**Medworth Energy from Waste Combined Heat and Power (EfW CHP)
Facility Project**

**APPLICATION BY MEDWORTH
CHP LIMITED
WRITTEN REPRESENTATION
PREPARED FOR RT HON.
STEVEN BARCLAY MP**

Dr Dominic Hogg

Figure 1: Evolution in Annual GHG Emissions from Incineration and Landfill Using Figures Recommended by Government for Use in Appraisal (tonnes CO₂e)

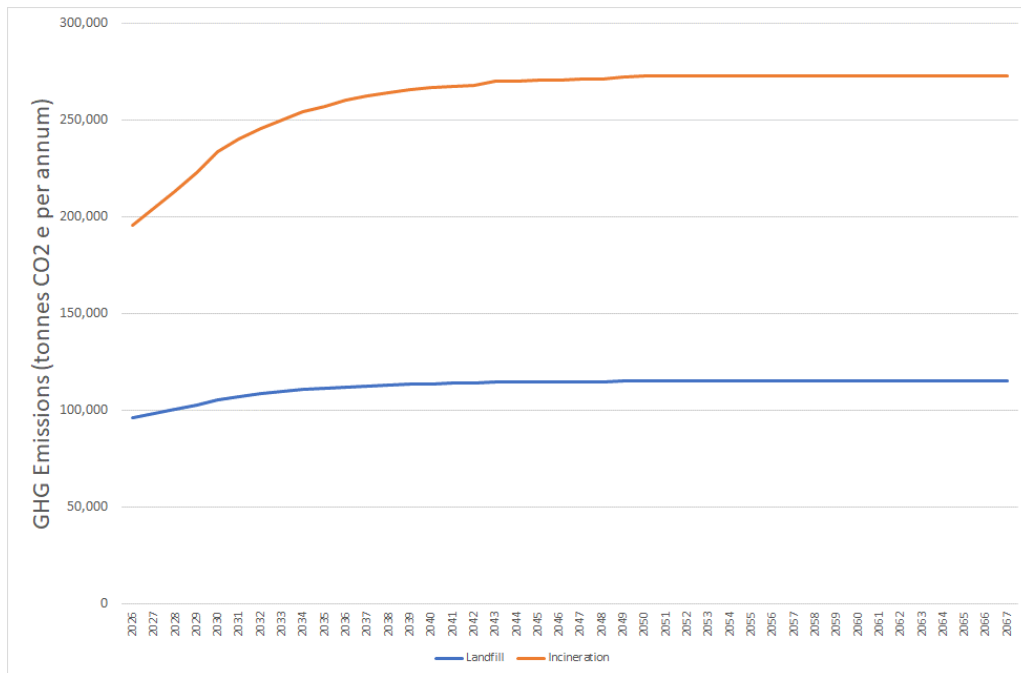
The figures change profoundly: the incinerator is no longer the lower emitter of greenhouse gases (expressed in terms of CO₂e).

We then implemented the second change also. Instead of using a constant figure for CO₂ 'saved' per unit of energy generated (182gCO₂/kWh), we used the long-run marginal carbon intensity related to generation (from Tables provided by what was then BEIS).¹¹ The annual emissions (net of 'avoided' CO₂ from power generation) from incineration and landfill evolve over time as shown in Figure 1. As power decarbonises, the credit per unit of power declines. This exerts a stronger effect on the outcome for incineration for the simple reason that it generates more energy. Over the 40 year life of the facility, the increase in emissions associated with incinerating rather than landfilling can be calculated as 5.934 million tonnes.

Figure 1: Reproduction of Figure 7 from Defra’s Evidence Showing Effects of Planned Reforms in Collection and Packaging

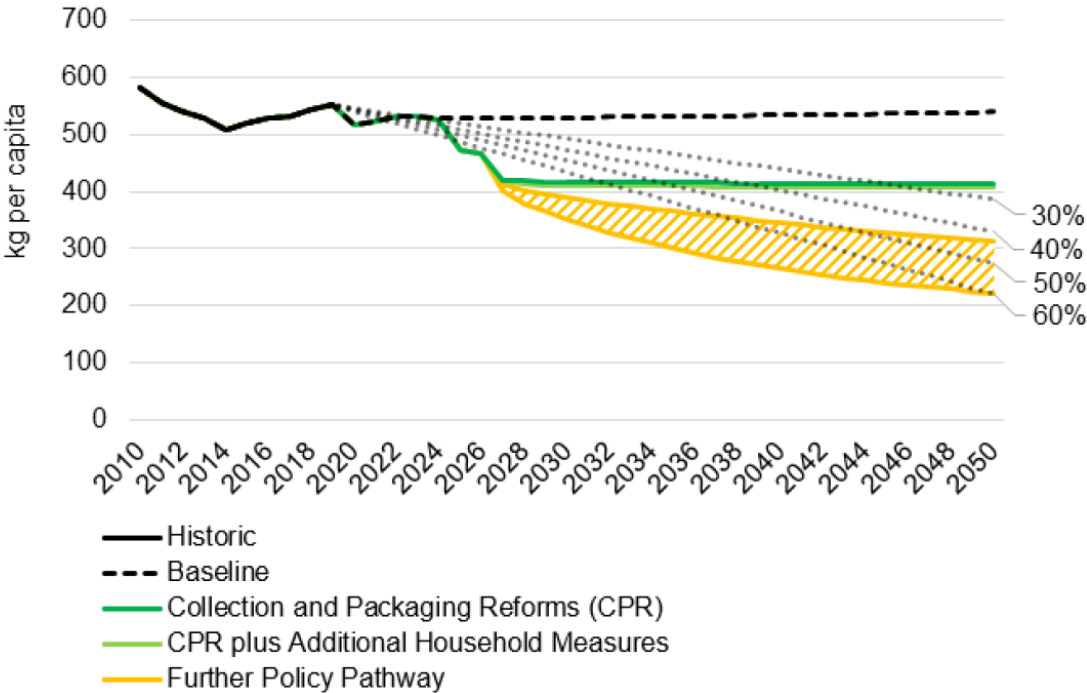
likely that if - as Defra indicates (see Figure 1) - changes already in the pipeline lead to a reduction in residual waste of the order 30%, then consenting this facility will indeed lead to overcapacity for incineration.

Figure 1: Evolution in Annual GHG Emissions from Incineration and Landfill Using Figures Recommended by Government for Use in Appraisal (tonnes CO₂e)

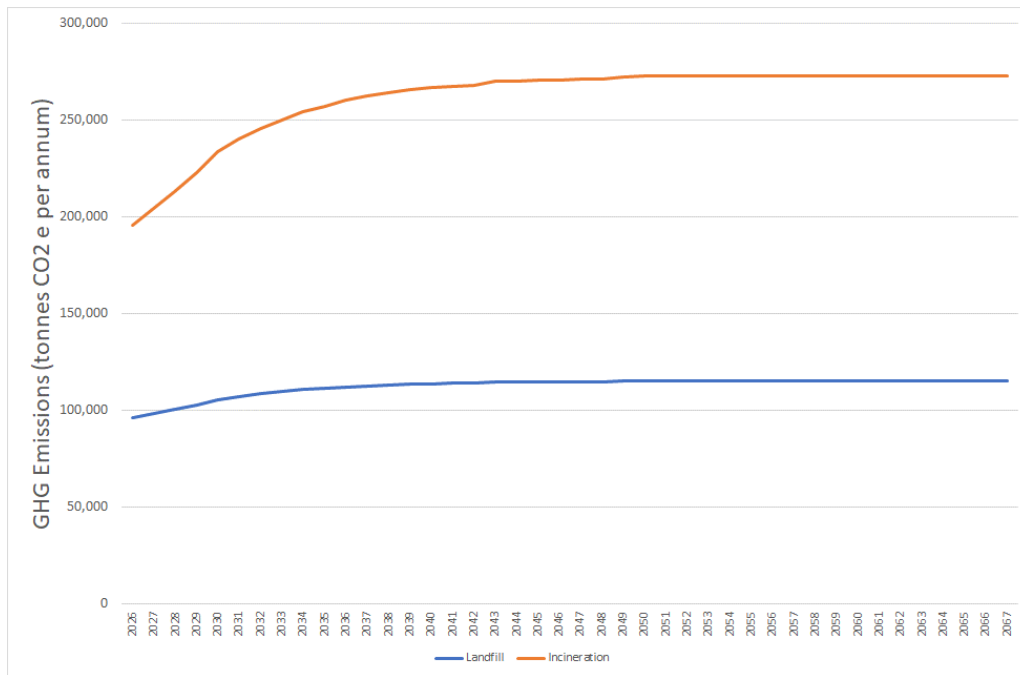
More correctly, using the long-run marginal carbon intensity related to generation (from Tables provided by what was then BEIS)⁸, annual emissions (net of ‘avoided’ CO₂ from power generation) would evolve as shown in Figure 1. As power decarbonises, the credit per unit of power declines. This exerts a stronger effect on the outcome for incineration for the simple reason that incineration generates more energy.

Over the 40 year life of the facility, the increase in emissions associated with incinerating rather than landfilling is 5.934 million tonnes.
